ZONING CHANGE REVIEW SHEET**CASE:** C14-2016-0087 – Cedar Willow Creek**P.C. DATE:**

ADDRESS: 2431 E. Oltorf Street**DISTRICT AREA:** 3**OWNER/APPLICANT:** Jimmy Nassour**AGENT:** South Llano (Glen Coleman)**ZONING FROM:** Community commercial (GR)**TO:** Multifamily residence
highest density (MF-6-CO)

AREA: 4.594 acres (200,114 sq ft)**STAFF RECOMMENDATION:**

Recommends Multifamily residence moderate – high density (MF-4).

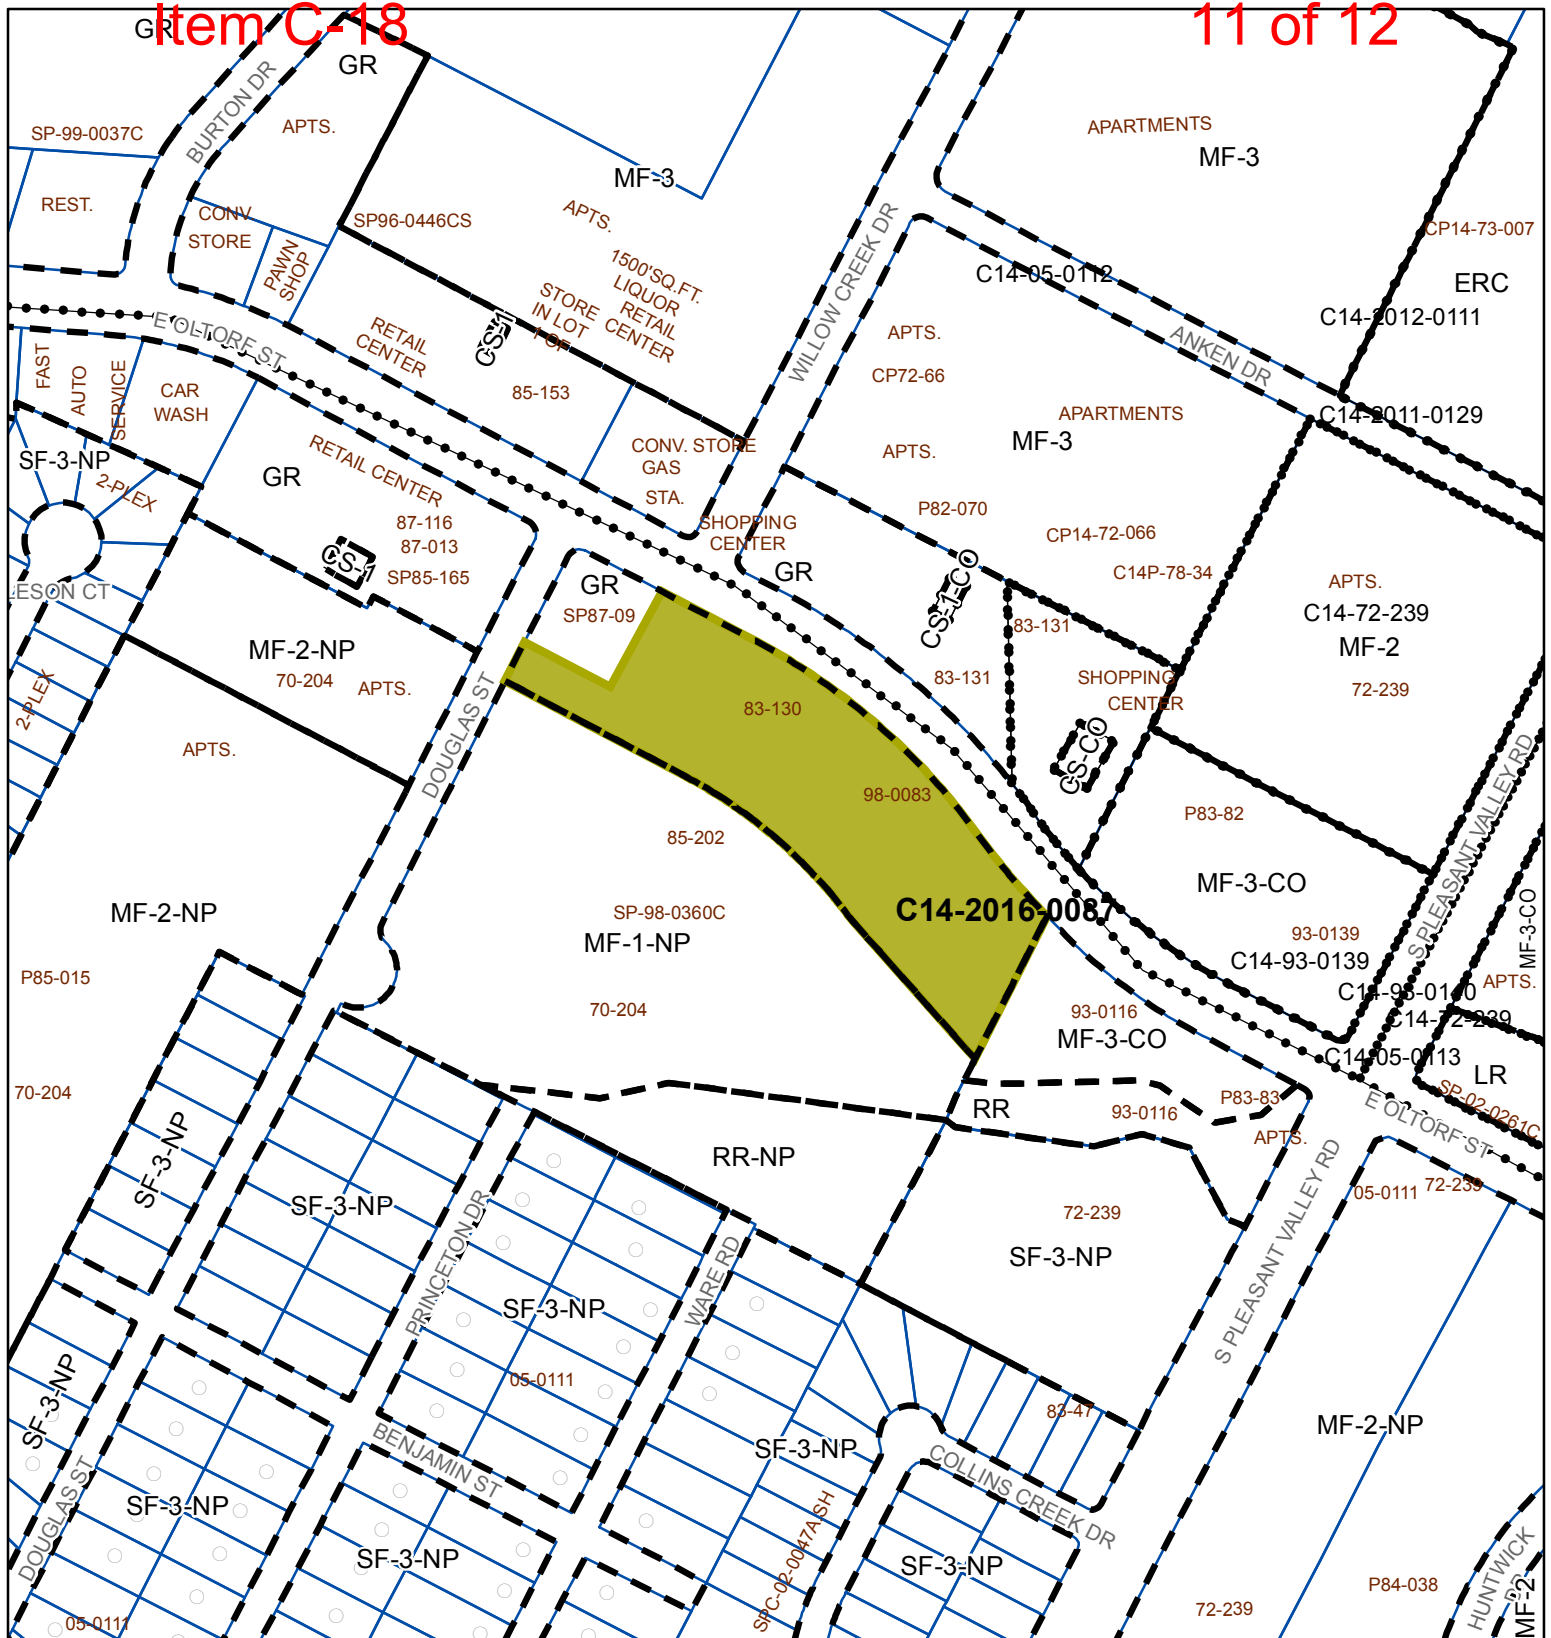
SP3) The site is subject to compatibility standards. Along the ***south and east*** property lines, the following height restrictions apply:

- for a structure more than 100 feet but not more than 300 feet from property zoned SF-5 or more restrictive, 40 feet plus one foot for each 10 feet of distance in excess of 100 feet from the property zoned SF-5 or more restrictive; or
- for a structure more than 300 feet but not more than 540 feet from property zoned SF-5 or more restrictive, 60 feet plus one foot for each four feet of distance in excess of 300 feet from the property zoned SF-5 or more restrictive.
